PRELIMINARY REVIEW SUMMARY REPORT FOR CLAIM NUMBER 5641; BP #11109, 4280 FOOTHILL BLVD, OAKLAND, CA

REVIEW SUMMARY REPORT – ADDITIONAL WORK THIRD REVIEW – DECEMBER 2013

USTCF Claim No.: 5641	GeoTracker Global ID: T0600100217
Site Name: BP #11109	Site Address: 4280 Foothill Oakland, CA 94601
Responsible Party 1: ConocoPhillips Attn: Terry Grayson	Address: 76 Broadway Street Sacramento, CA 95818
Responsible Party 2: Khalid and Ramona Usman	Address: 3670 Ralston Avenue Hillsborough, CA 94010
Responsible Party 3: Paul Supple	Address: PO Box 1257 San Ramon, CA 94583
USTCF Expenditures to Date: \$589,052	Number of Years Case Open: 23

- Since 1989, twelve groundwater monitoring wells have been installed and regularly monitored. Benzene trends of select wells are shown below:

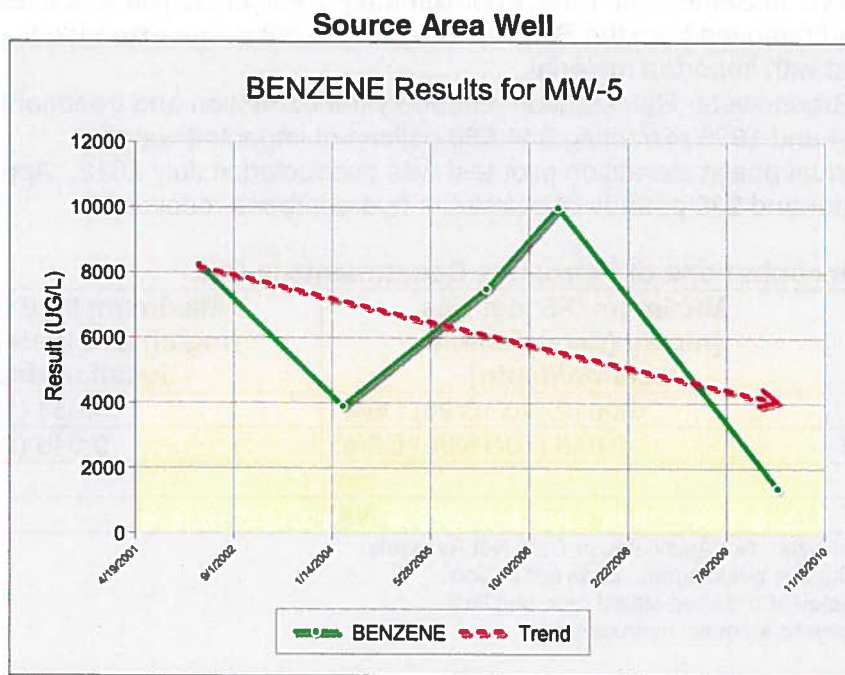
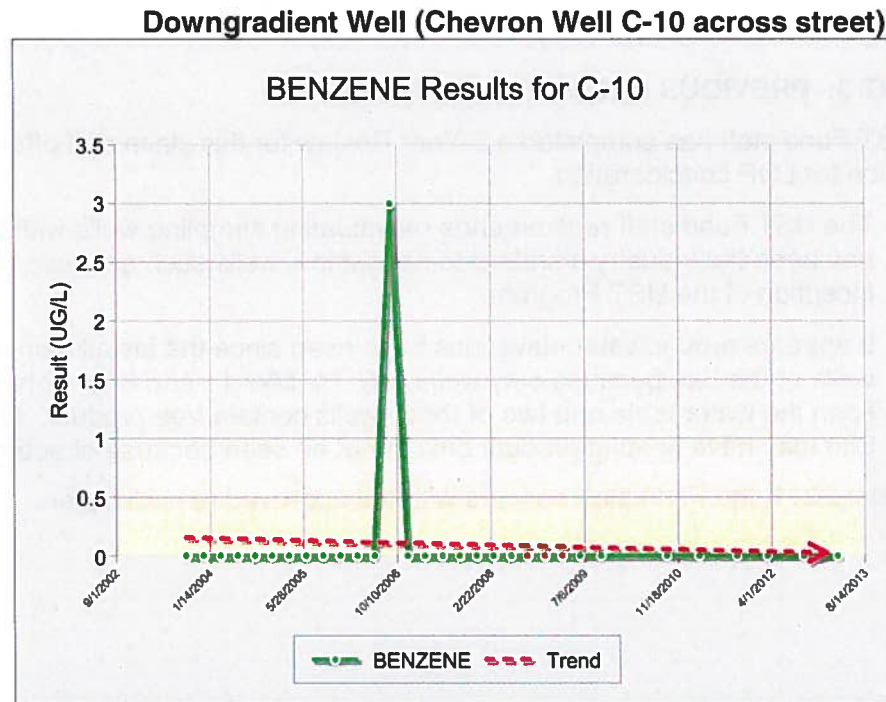
- Plume Length: <100 feet.
- Plume Stable or Decreasing: Yes.
- Contaminated Zone(s) Used for Drinking Water: No.
- Groundwater Specific Criteria: The case fails, because recoverable free product is present
